Project: Gas Holder Site, Reading

SMA Ref: 5757

Subject: Response to Highways Consultation Comments

Revision: A

SECTION 278 WORKS PLAN

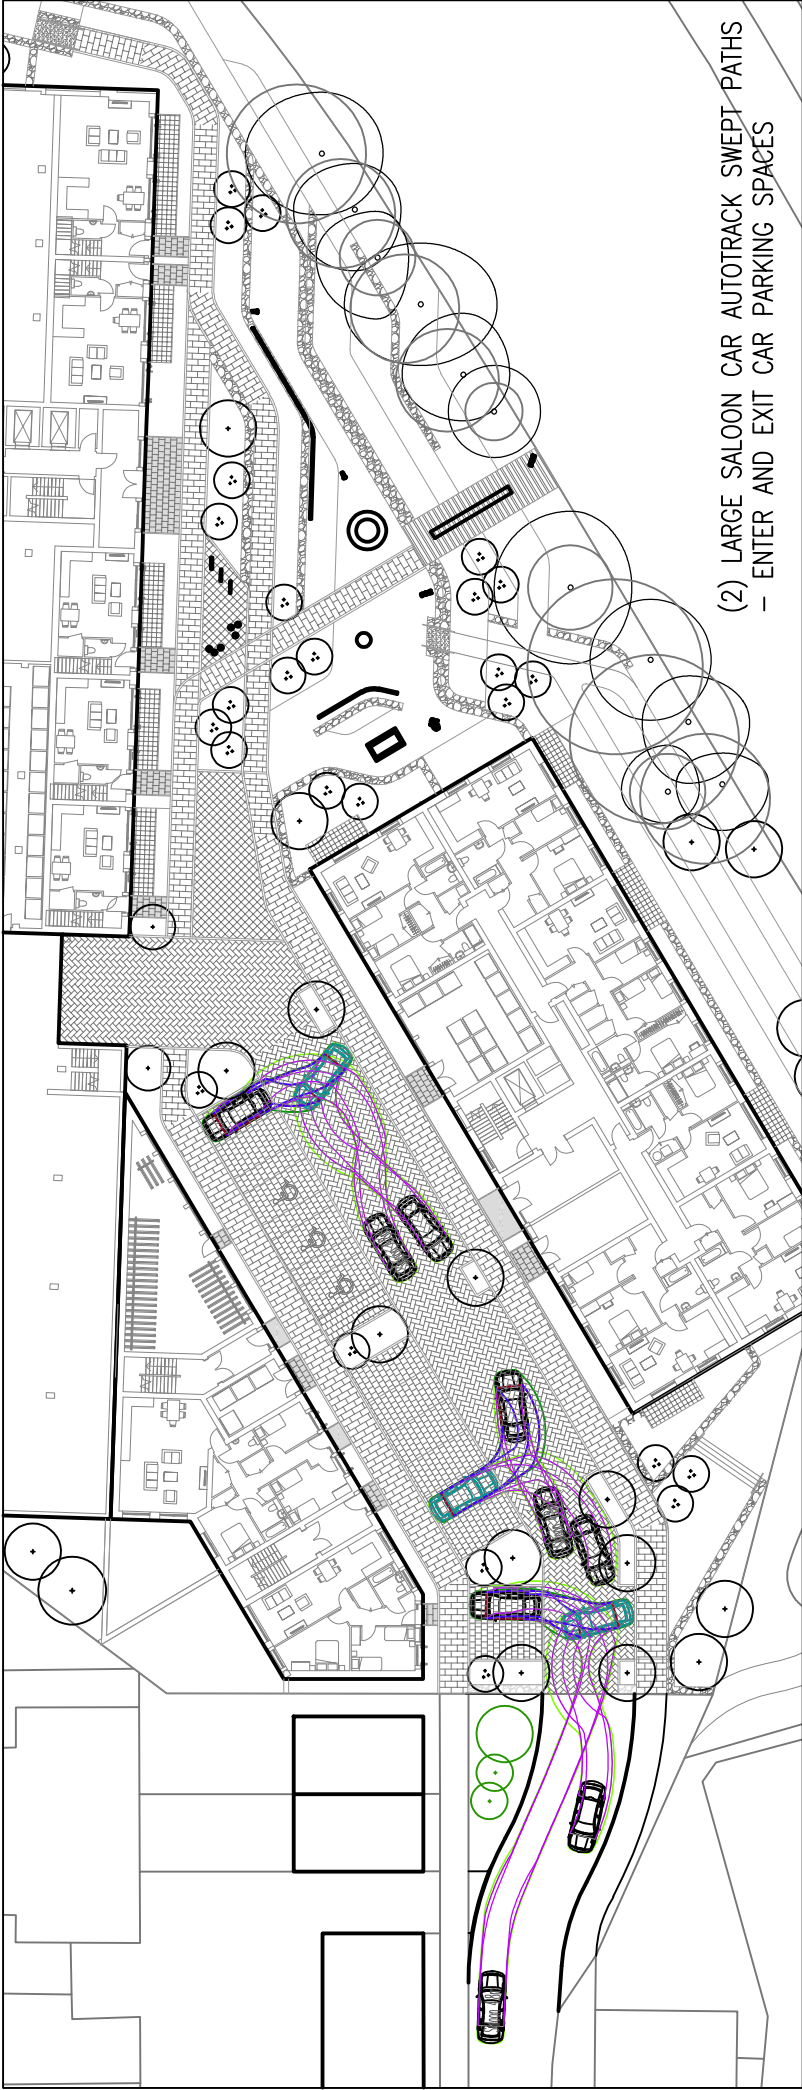
- 2.1. The consultation response set out the requirement for a drawing showing the works to be completed under S278 to show the proposed connection to Alexander Turner Close. This is attached as **Drawing 5757.001**. This drawing shows the proposed connection, alongside the area of landscaping previously discussed with RBC and the connection to the footway on the southern side of the existing carriageway.

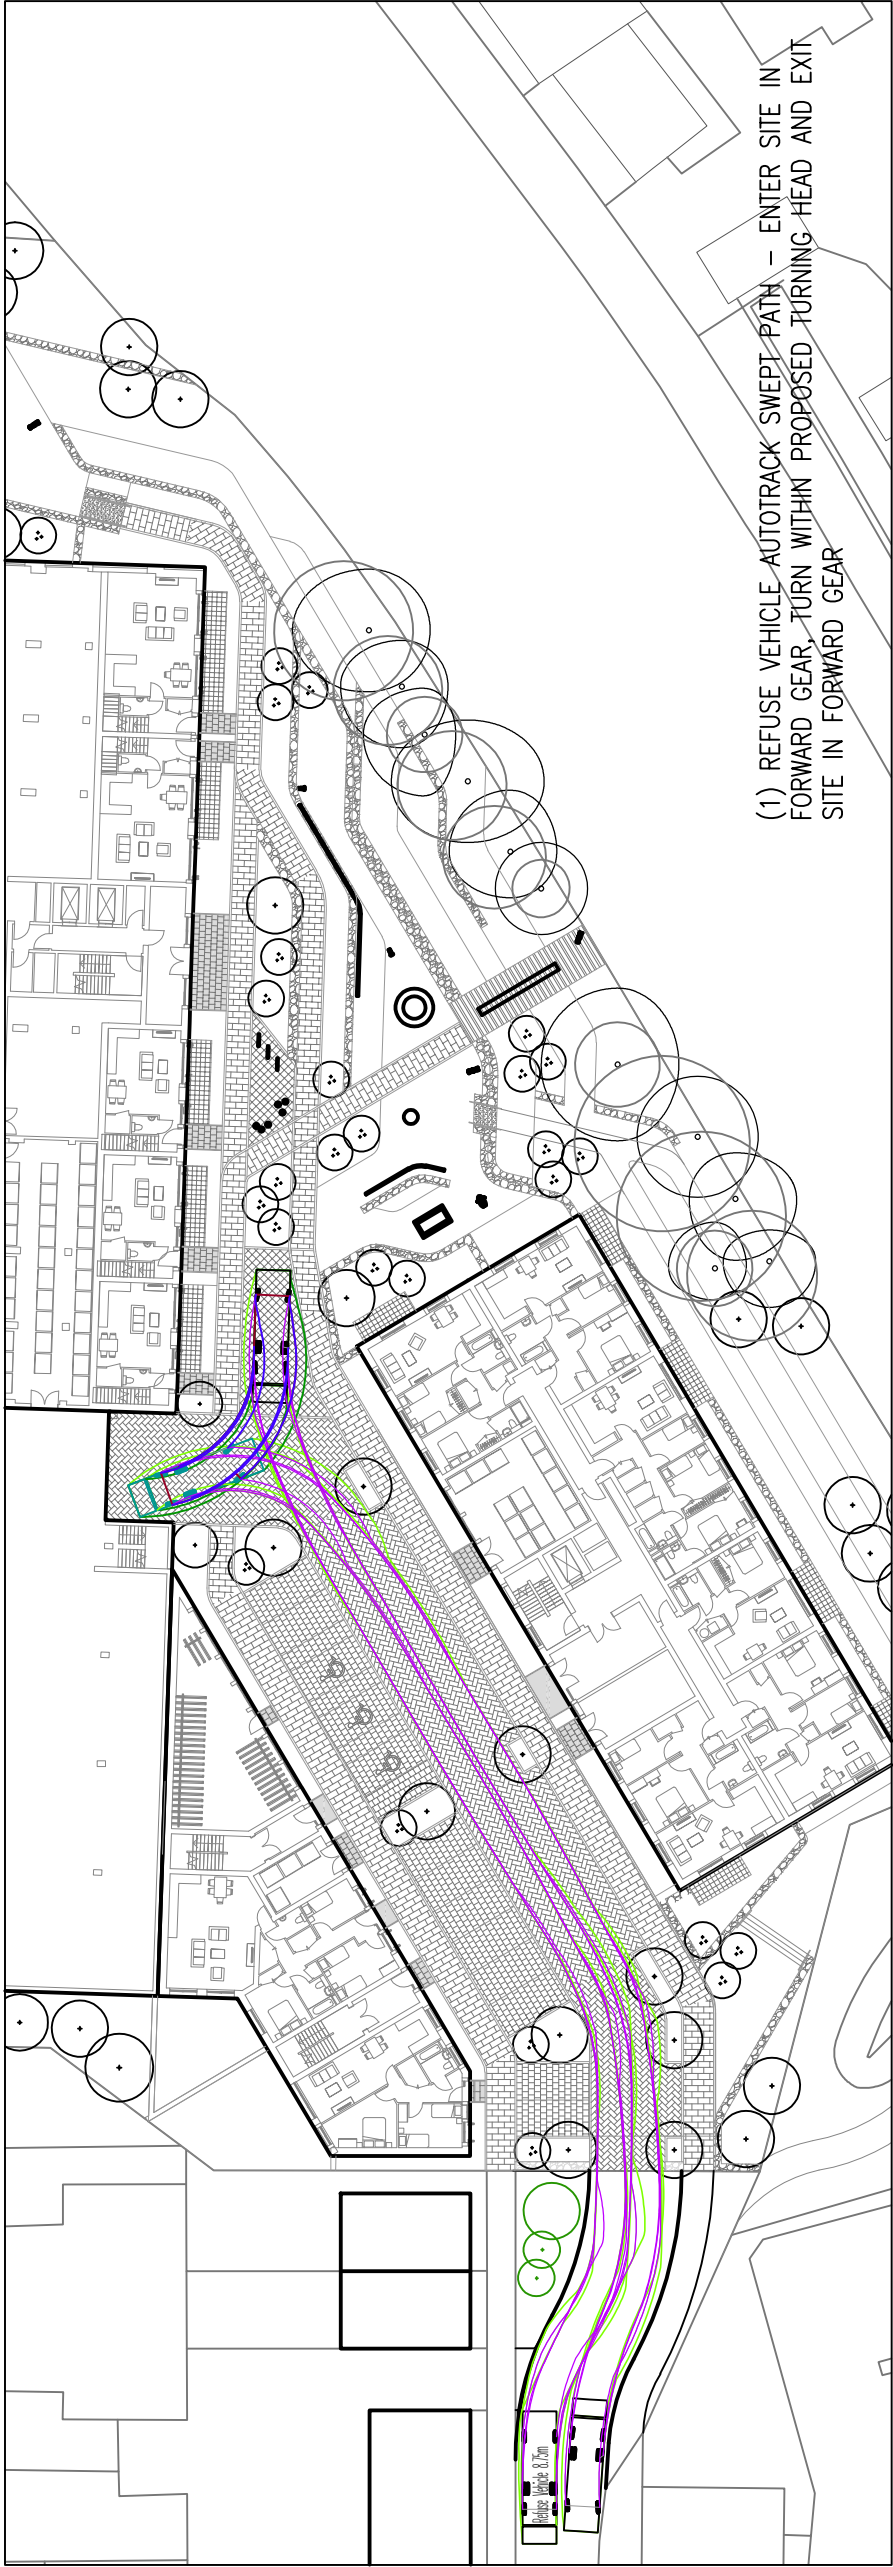
- 4.1. As requested by RBC, the tracking drawing has been updated to consider the proposed S278 works to Alexander Turner Road. This indicates that the expected vehicles can safely enter and leave the site. This is shown in **Drawing 5757.SK10D**.

- 4.2. In reference to the turning head within the site, it is proposed that the carriageway inclusive of the turning head be a shared surface. It should also be noted that the refuse will only use the turning head once a week and the number of pedestrians on the shared surface limited to residents of the site (as there is no through route currently available). The likely conflict and therefore risk to pedestrian safety is limited. The manoeuvre of the refuse vehicle is therefore not considered a safety issue.

- 4.3. The site layout plan has been update to remove the cosmetic surfacing which indicated possible routes for pedestrian. The plan now shows the turning head clearly as shared surface and this will be at grade as well as minor amendments to the pedestrian route. It was agreed that this change would overcome the highways concerns to this point. This is shown in **Drawing 5757.SK10D**.
